Agenda Item #2 SUB-002695-2023

R.C. Washington Subdivision

- Subdivision approval to create two (2) legal lots of record from two (2) metes-and-bounds parcels.

R. C. WASHINGTON SUBDIVISION

SITE PLAN

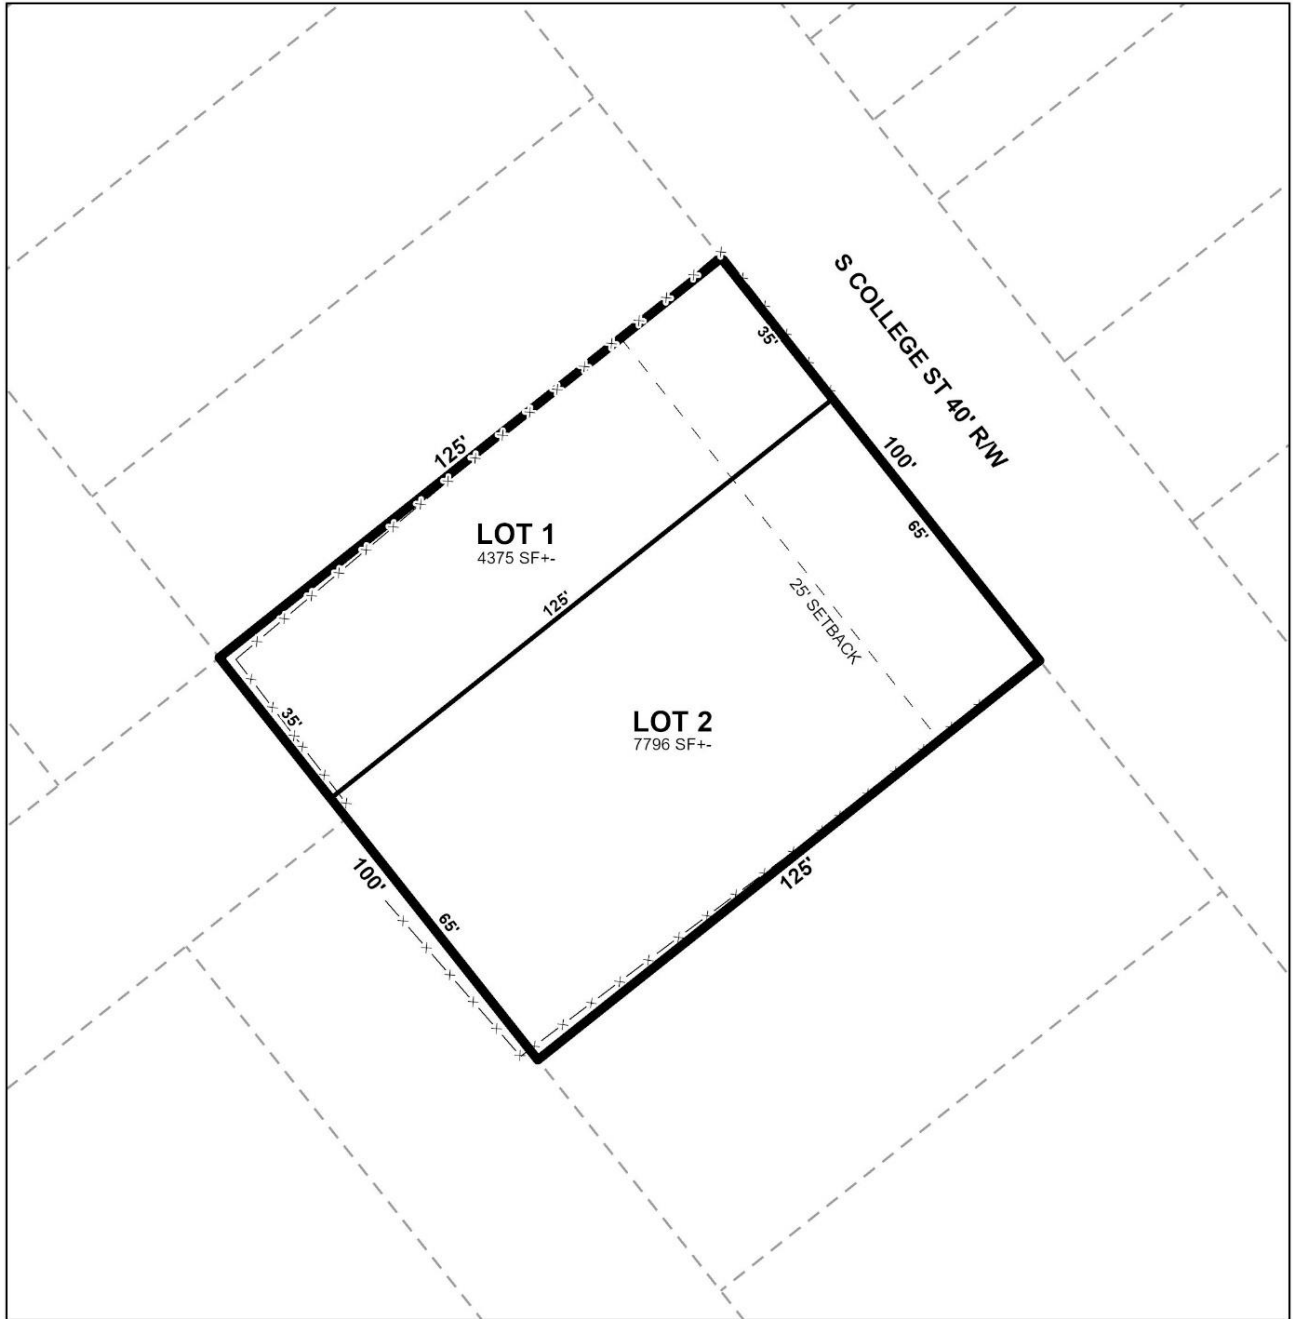
The proposed lots have frontage along College Street and Golden Avenue, both minor streets with curb and gutter and 40-foot rights-of-way at this location. Adequate right-of-way is depicted along both streets on the preliminary plat and should be retained on the Final Plat, if approved.

Golden Avenue is a closed-end street that terminates at the subject site. As such, a turnaround is typically required to be provided, the right-of-way diameter for which is to be determined by the City Engineer, in compliance with the International Fire Code. However, the size of the proposed lots suggests that a turnaround may not be feasible at this time. If a turnaround is not required by the City Engineer, a waiver of Sections 6.B.3. and 6.B.9 of the Subdivision Regulations will be required for approval of the Final Plat.

It should be noted that College Street is labeled as "South College Street" on the preliminary plat. As such, if approved, the plat should be revised to correctly label College Street.

Lot 1, as proposed, does not meet the minimum 6,000 square-foot size requirement of Article 2, Section 64-2-5.E. of the UDC for lots in the R-1, Single-Family Residential Urban district. It also does not meet the minimum 50-foot width requirement of Section 6.C.2(b)(3) of the Subdivision Regulations for residential lots in the urban sub-district. Substandard lot sizes and lot widths are not uncommon within the vicinity of the subject site as it is located in an older part of the City. Lots across College Street vary in width from 20 to 40-feet wide, and areas ranging from 2,500 square feet to 5,000 square feet. Therefore, approval of the request may be in character with the surrounding neighborhood. If approved, waivers of Sections 6.C.2(a)(1) and 6.C.2(b)(3) will be required to allow the reduced lot size and lot width, respectively.

If approved, Lot 1 would exceed the maximum 3.5 width-to-depth ratio of Section 6.C.3 of the Subdivision Regulations. Again, this does not appear to be uncommon within the surrounding area, but approval of the Final Plat will require a waiver of Section 6.C.3.

As mentioned, the proposed lots have frontage on two (2) streets, which is discouraged by Section 6.C.7 of the Subdivision Regulations. Considering the parcels in their existing configuration have double street frontage, a waiver of Section 6.C.7 may be appropriate; however, if approved, a note should be placed on the Final Plat stating each lot is denied access to Golden Avenue.

A 25-foot front yard setback is illustrated along College Street, but only a 5-foot front yard setback is required for lots in the R-1, Single-Family Residential Urban District, per Article 2 Section 64-2-5.E. of the Unified Development Code (UDC). The applicant may retain the 25-foot setback, but if approved and the plat recorded in Mobile County Probate Court depicts a 25-foot front yard setback, future development of the properties will be subject to a front yard setback that is greater than what is required by the UDC. As such, at least a 5-foot front yard setback should be illustrated along College Street on the Final Plat, if approved.

No front yard setback is illustrated along Golden Avenue; therefore, if approved, at least a 5-foot front yard setback should be illustrated along Golden Avenue on the Final Plat, in compliance with Article 2, Section 64-2-5.E. of the UDC.

Recent aerial photos depict a structure on proposed Lot 1, but in a conversation with staff, the applicant stated that it has been demolished. Staff finds no permit documenting demolition of the structure; therefore, an after-the-fact Demolition Permit may be required, prior to the approval of any permits to redevelop the property.

1. Retention of the right-of-way widths as illustrated on the preliminary plat;
2. Revision of the Final Plat to correctly label "College Street";
3. Retention of the lot sizes in both square feet and acre on the Final Plat, or provision of a table on the Final Plat with the same information;

4. Placement of a note on the Final Plat stating each lot is denied access to Golden Avenue;
5. Retention of at least a 5-foot front yard setback line along College Street, in compliance with Section 64-2-5.E. of the Unified Development Code;
6. Revision of the Final Plat to illustrate at least a 5-foot front yard setback along Golden Avenue;
7. Acquisition of an after-the-fact Demolition Permit for the structure on Lot 1 prior to the approval of any development permits;
8. Compliance with all Engineering comments noted in this staff report;
9. Placement of a note on the Final Plat stating all Traffic Engineering comments noted in this staff report;
10. Compliance with all Urban Forestry comments noted in this staff report; and,
11. Compliance with all Fire Department comments noted in this staff report.
